BARANGAROO SOUTH

Stage 1B Public Domain Modification S4.55 Development Application Report

Mod Application Overview

WATERMANS COVE DETAIL PLAN

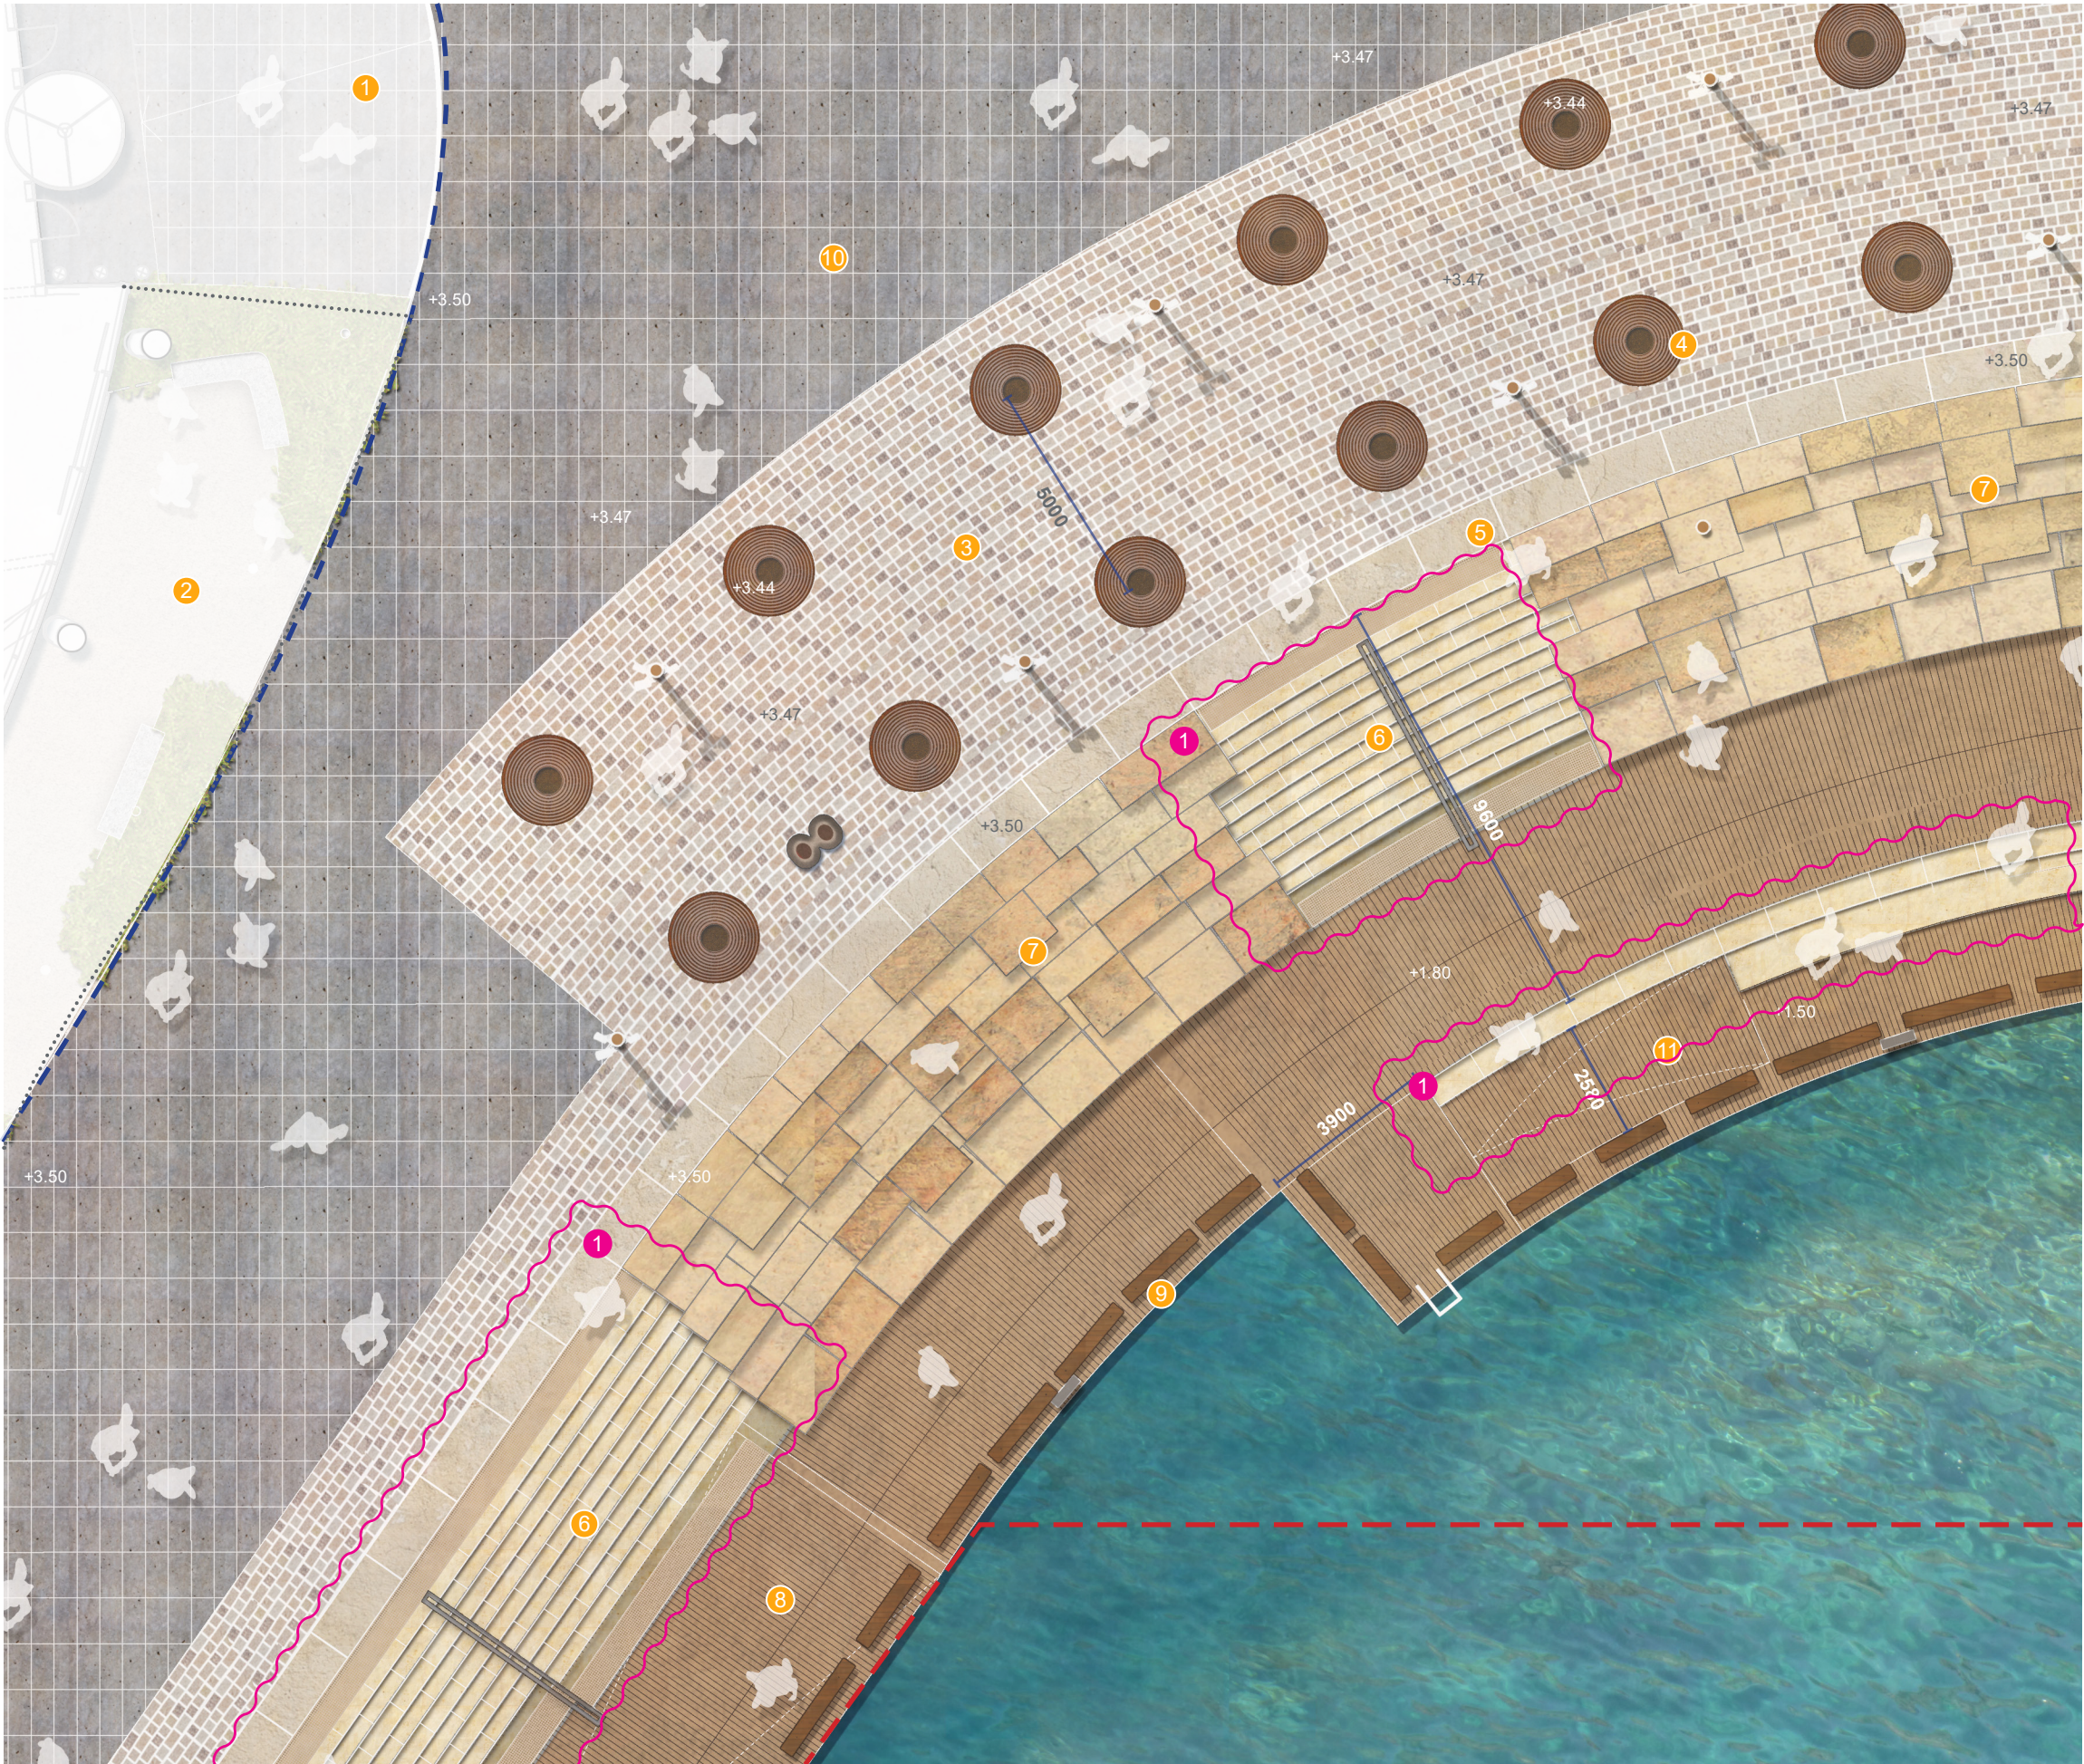
- Amendment cloud
- 1 Stone stairs changed to concrete

HICKSON ROAD BOLLARD STRATEGY

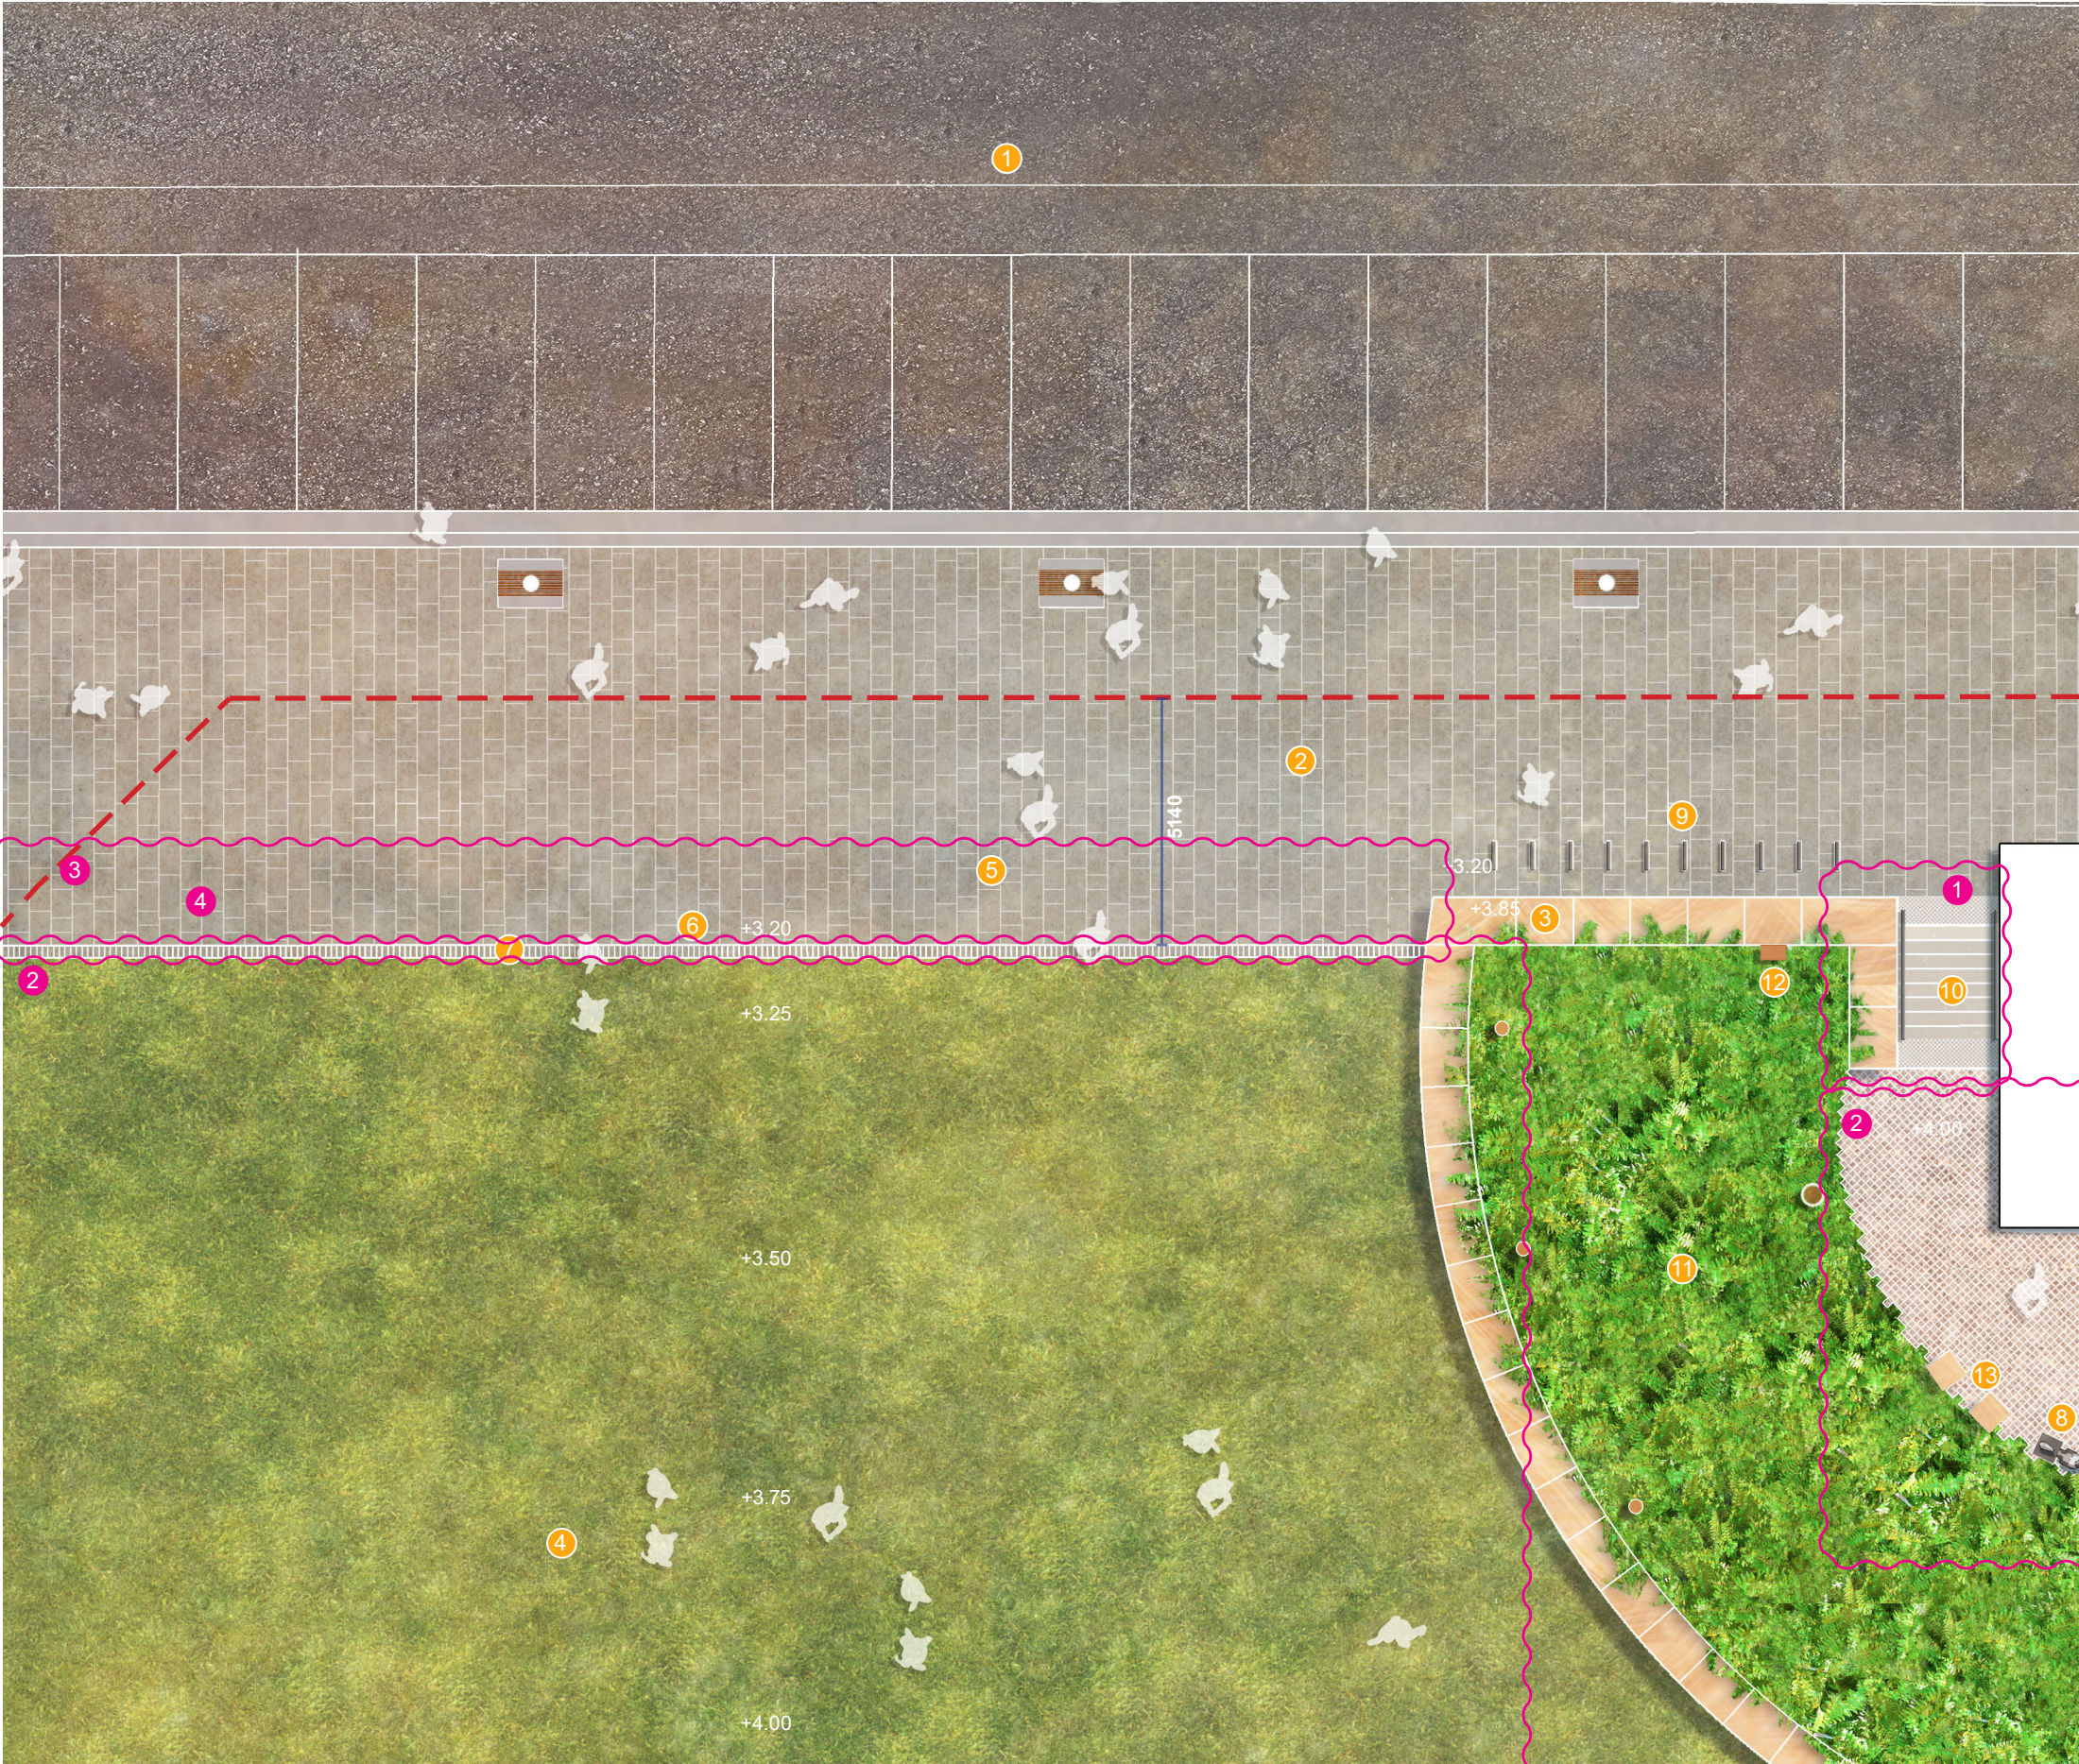
- Amendment cloud
- 1 Stone stairs changed to concrete
- 2 Levels changed due to proposed Hickson Road levels
- 3 Sandstone paving strip change to City of Sydney paving along Hickson Park
- 4 Sandstone bollards changed to concrete & delete bollards to East park edge.
